Case No. 05-2188-cv-JPM-tmp

CONSENT ORDER

APPENDIX B.1
South Bluffs Apartments

APPENDIX C.1
Island Park Apartments
(Memphis, TN)
Exterior Accessible Route Plan
and Unit Plans

APPENDIX J.1
 Horizon Condominiums
 Exterior Accessible Route Plan

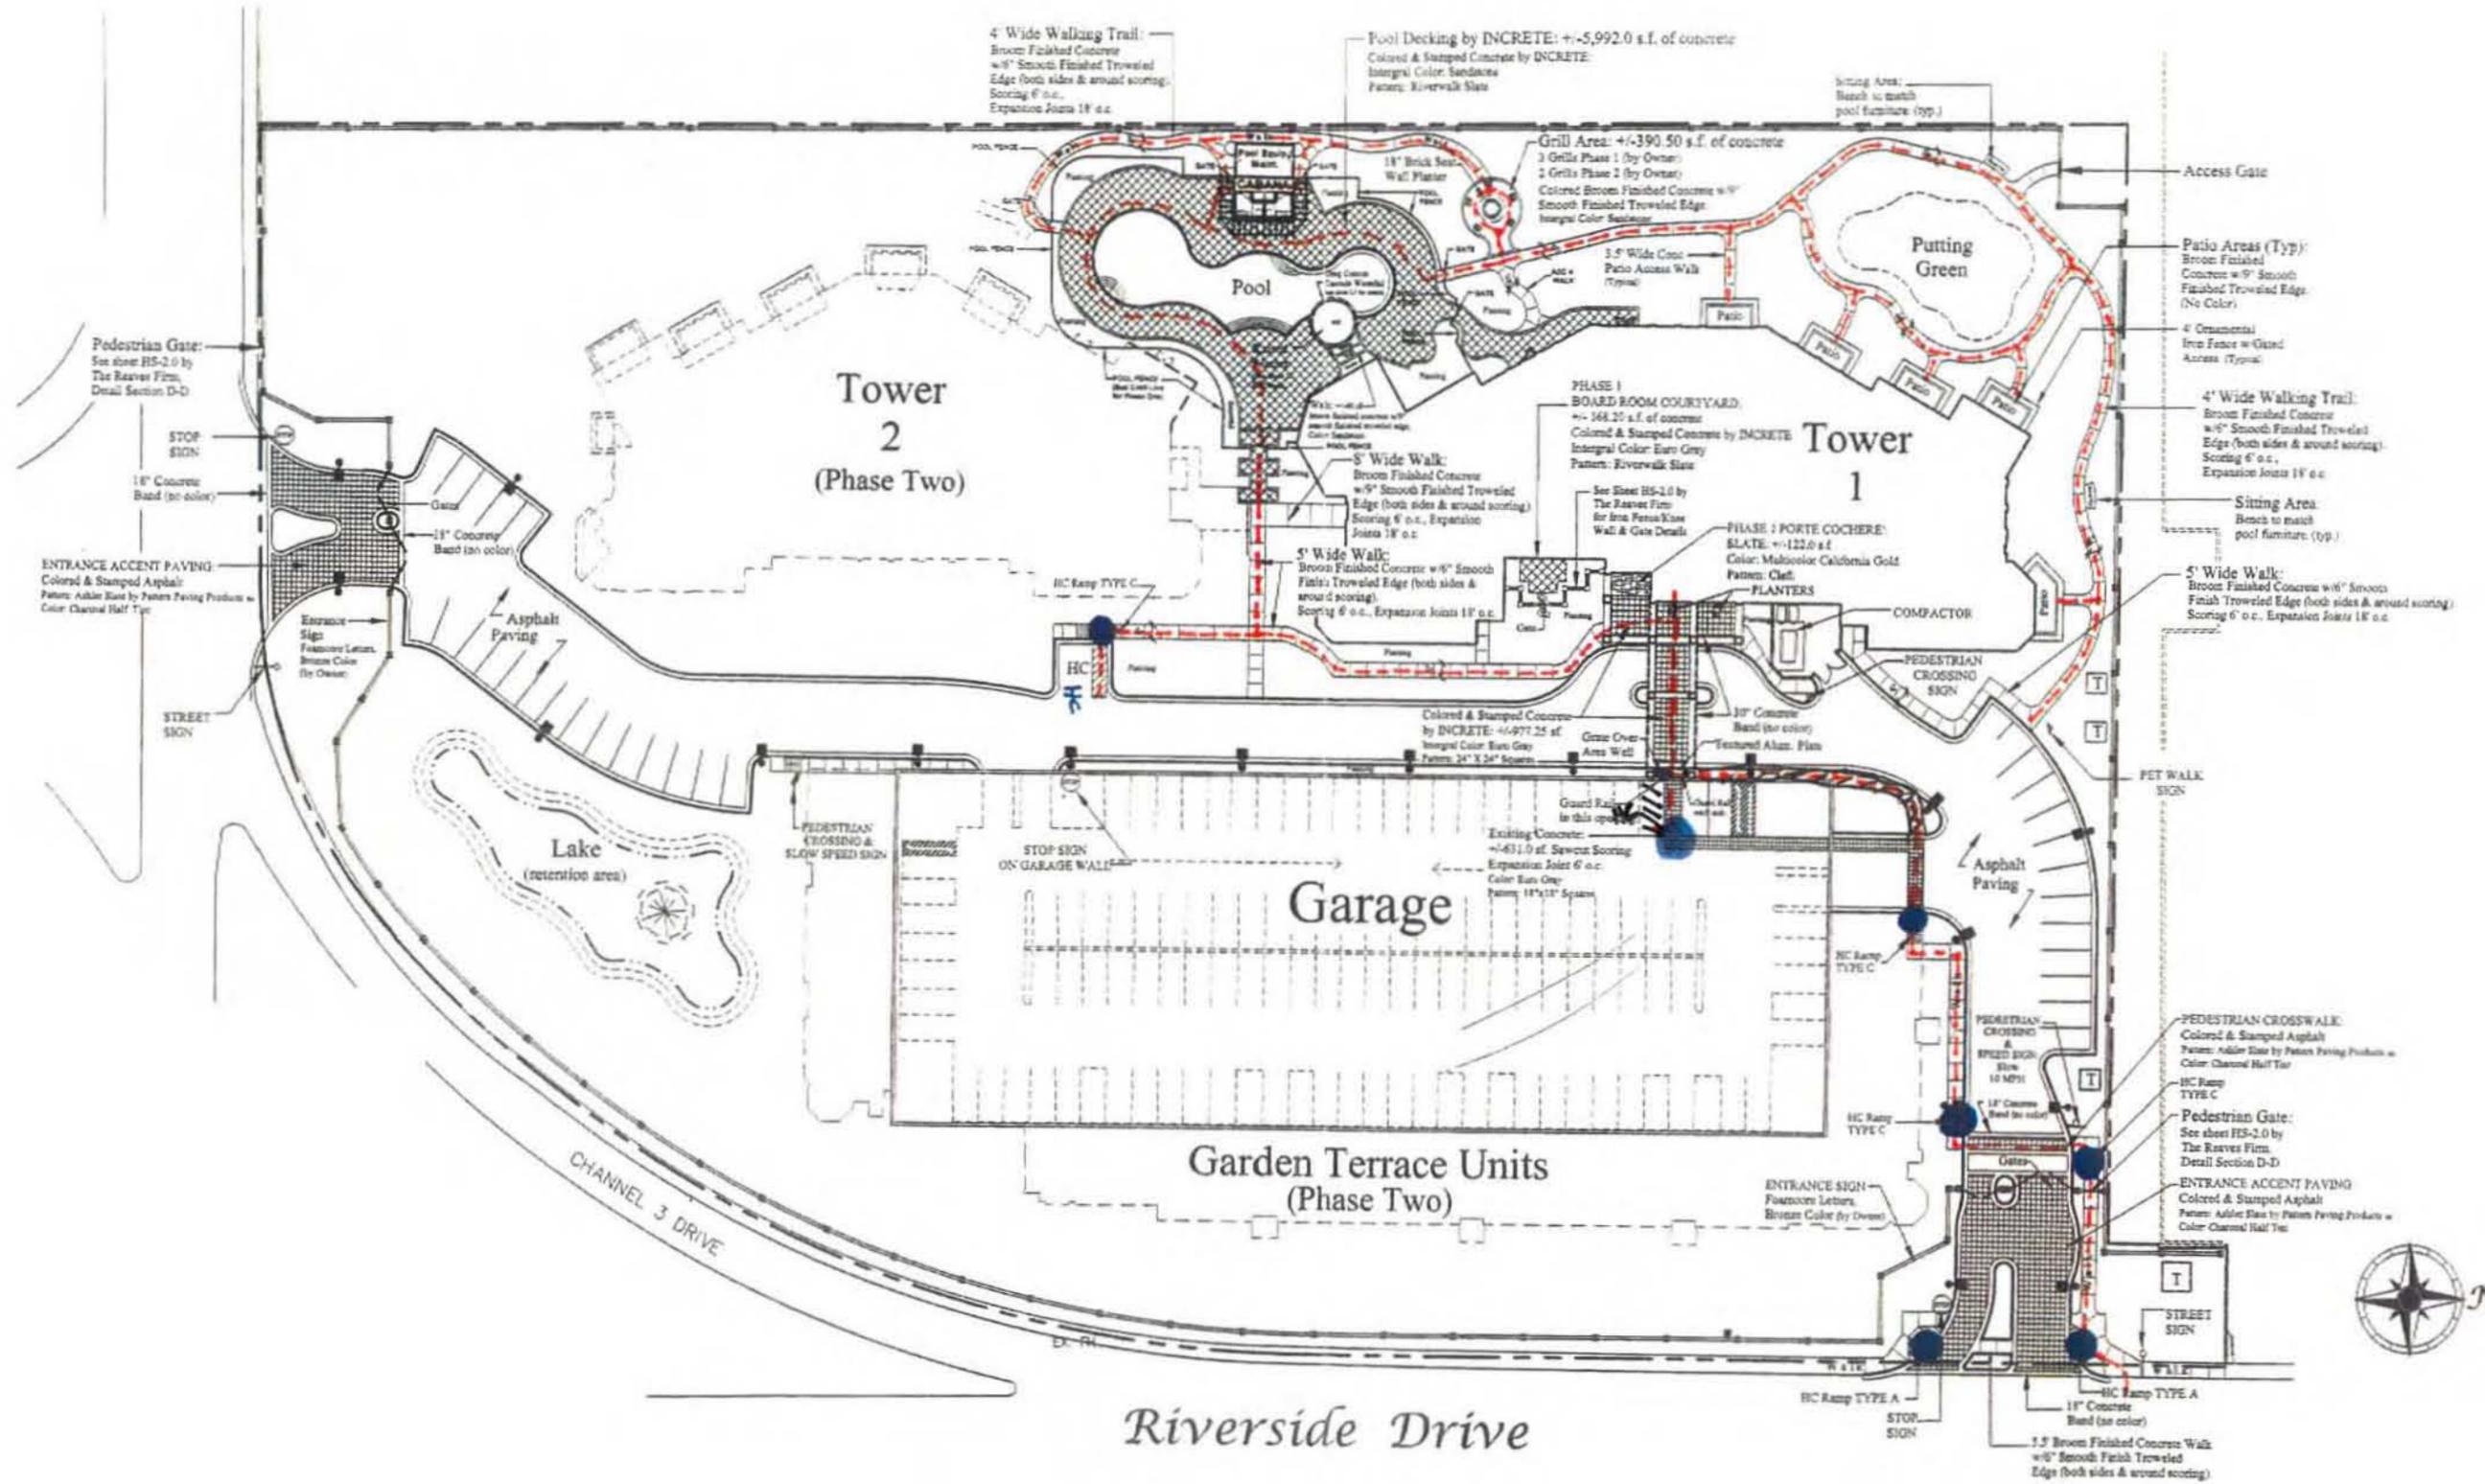
2	11	b.	The back wall of the bathtub in the Master Bath lacked wood blocking for the lower of the double grab bar installation on the tub back wall. 0142, 0144, 0145 [FHAG Requirement #7, guide (2)(a)]	Provide affidavit confirming the presence of wood blocking for the lower of the double grab bar installation on the tub back wall compliant with FHAG Requirement #7, guide (2)(a)
3	13	d	The side wall at the water closet in the provided only partial wood blocking for the installation of a side grab bar. 0147, 0148 [FHAG Requirement #6, Figure 3]	Provide affidavit confirming the presence of wood blocking for the installation of a side grab bar that is compliant with FHAG Requirement #6, Figure 3
	14	5	Level Eight North Wing - Unit C1 - 3 Bedroom, 2.5 Baths	
4	15	a,	The rear wall at the water closet provided only partial wood blocking for the installation of a rear grab bar centered on the water closet. 0158, 0160 [FHAG Requirement #6, Figure 3]	Provide affidavit confirming the presence of wood blocking for the installation of a rear grab bar centered on the water closet that is compliant with FHAG Requirement #6, Figure 3

13	31	d	The back wall of the bathtub in the Master Bath lacked wood blocking for the double grab bar installation on the tub back wall. 0319, 0320 [FHAG Requirement #7, guide (2)(a)]	Provide affidavit stating that wood blocking was provided and/or revised within 6" of corner and within 6" high of bathtub rim (see FHADM 6.9 for reinforcing diagram at conventional bathtub)
14	32	e	The side wall at the water closet in the Master Bath provided only a 24" length, less than the specified minimum 36" length required for a side grab bar. 0324, 0326 [FHAG Requirement #6, Figure 3]	Provide affidavit confirming the presence in all 3 bedroom, den, 3 bath units (Type B4), of wood blocking for fold down grab bar compliant with FHAG Requirement #6, Figure 3
